**CITY OF POMPANO BEACH
DRC COMMENT RESPONSES**

CASE NUMBER: PZ23-12000046

Request: Major Site Plan

Project Location: 31 NE 22 Avenue

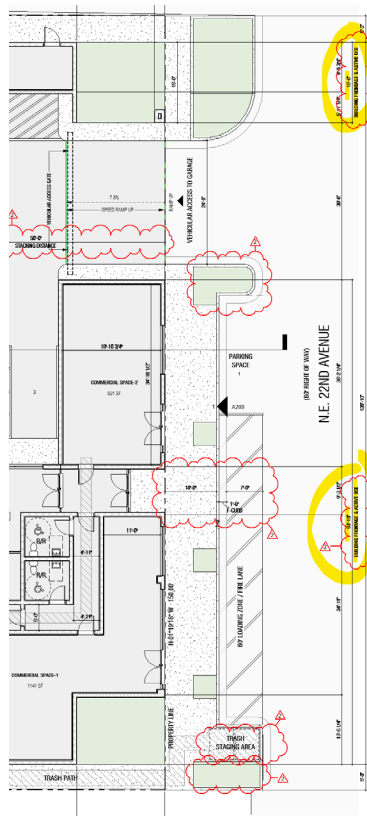
5. The response to previous comment #3 states that the 2 overhead doors are for the trash room and for the storage room. However, the overhead door for the storage room opens onto a landscape area, not a paved walkway. Address this issue.

RESPONSE: This exterior overhead door in Storage has been relocated and no longer has exterior access. Please refer to Sheet A100 for updates.

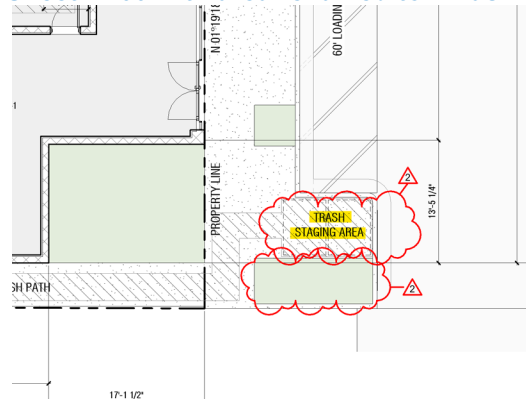
2. Make sure the site plan and the ground floor plan both show the poured concrete pad for the staging area. Currently, only the ground floor plan shows it.

RESPONSE: The poured concrete pad has been added.
